SUBJECT: TEDS Exception for 1st National Bank of the Rockies
at Meridian Park Subdivision on Orchard Mesa

DESIGN EXCEPTION #DE 4-05

RE: Access Serving Off-Street Parking Areas – 1st National bank of the Rockies

Re: Design Exception #DE4-05 – Access Serving Off-Street Parking Areas

PROPOSED SITE PLAN
NOT TO SCALE

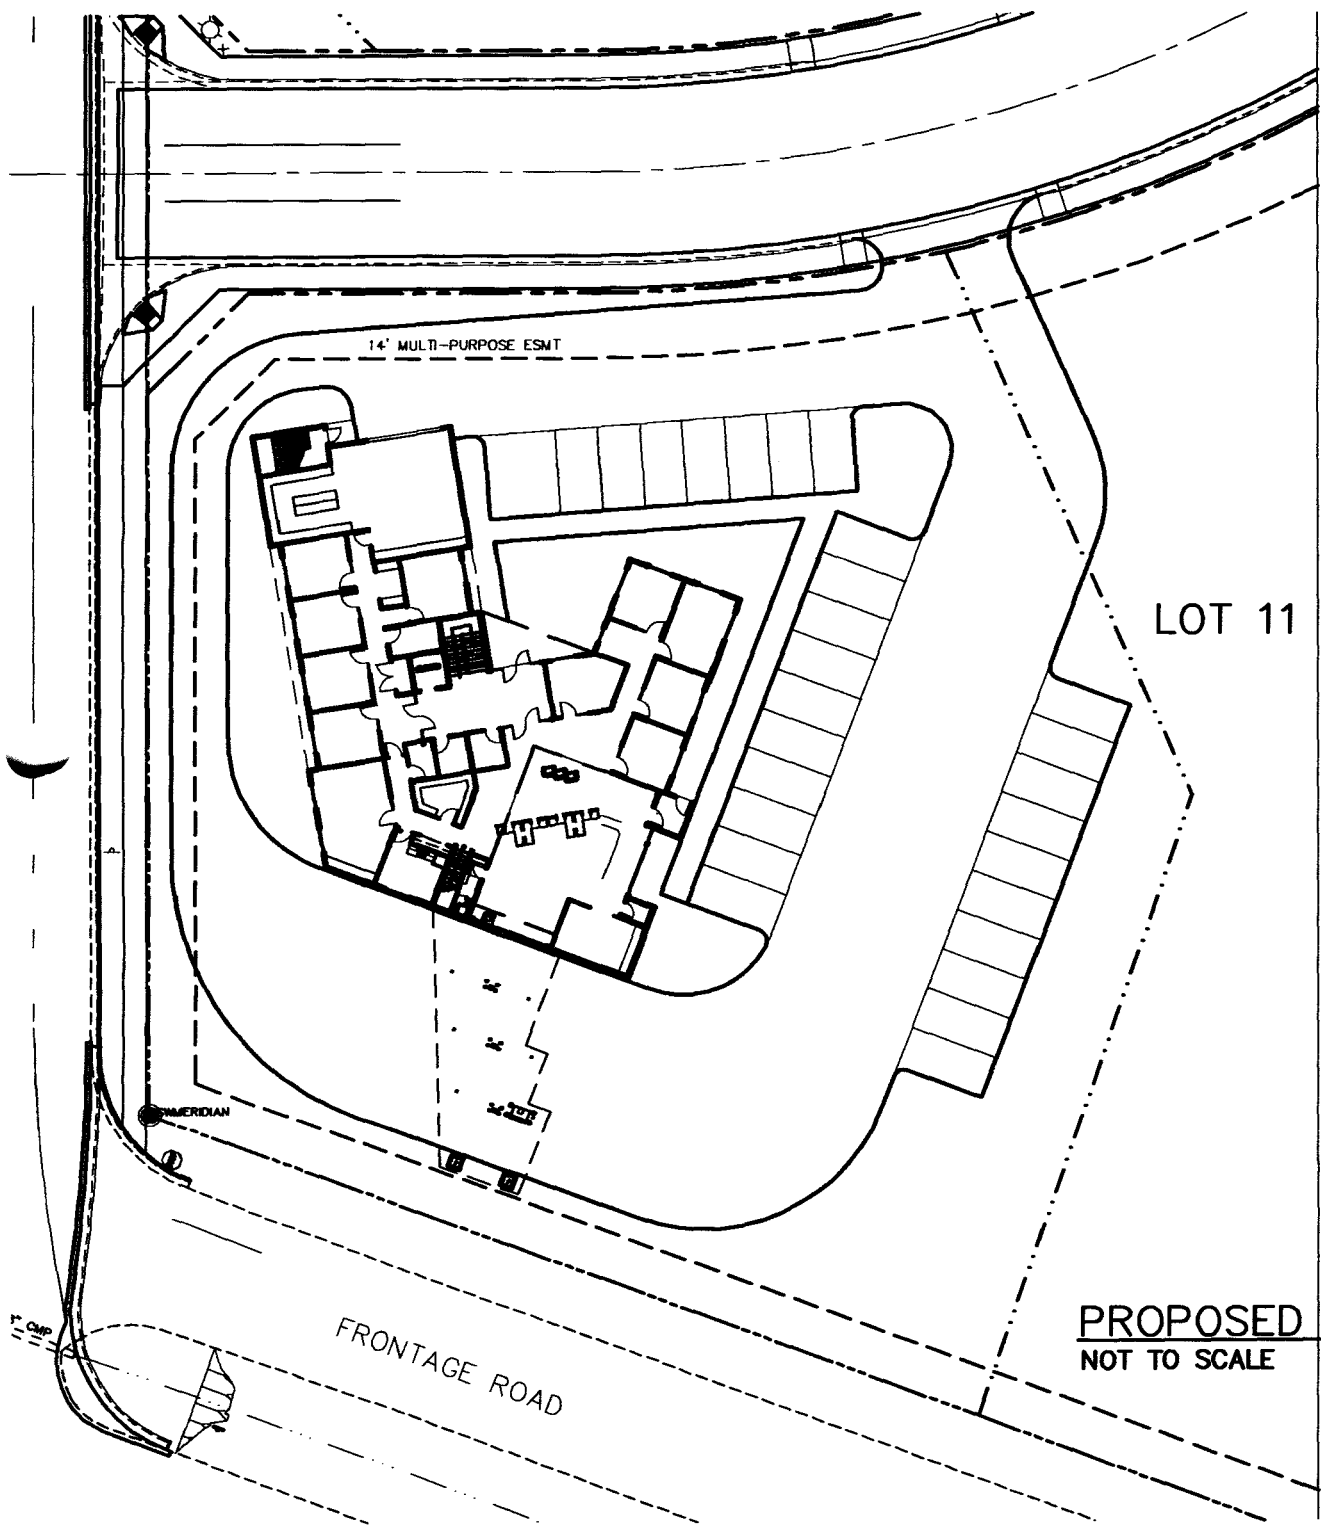
Proposed Design – The proposed design is to provide for (4) Drive-up Teller Windows (1 being a ATM) with a one-way loop road around the proposed building. Each Teller Window will be able to queue (2) cars together. The loop road will be able to queue (9+) additional cars. Proposed site plan is attached in the Appendix.

The applicant proposes to construct a branch bank at Meridian Park Subdivision on Orchard Mesa. Their plan accommodates two vehicles at each of four windows plus nine more in the approach lane. TEDS requires a minimum of six spaces per window.

This reduced storage creates the potential for waiting bank customers to backup into the rest of the bank's parking lot. Data indicates that this will not be the case. In any event, it will not compromise safety on City streets.

Staff recommends approval of this Design Exception to the second table in Section 4.2.5.1 to allow reduced vehicle storage at this branch bank drive-up facility. I would also recommend that the standard be adjusted to require a minimum of three spaces per window at branch banking facilities.

Please find attached the committee's decision for the above referenced request. This design exception has been approved as requested. You may use this decision to proceed through the development review process for this exception.
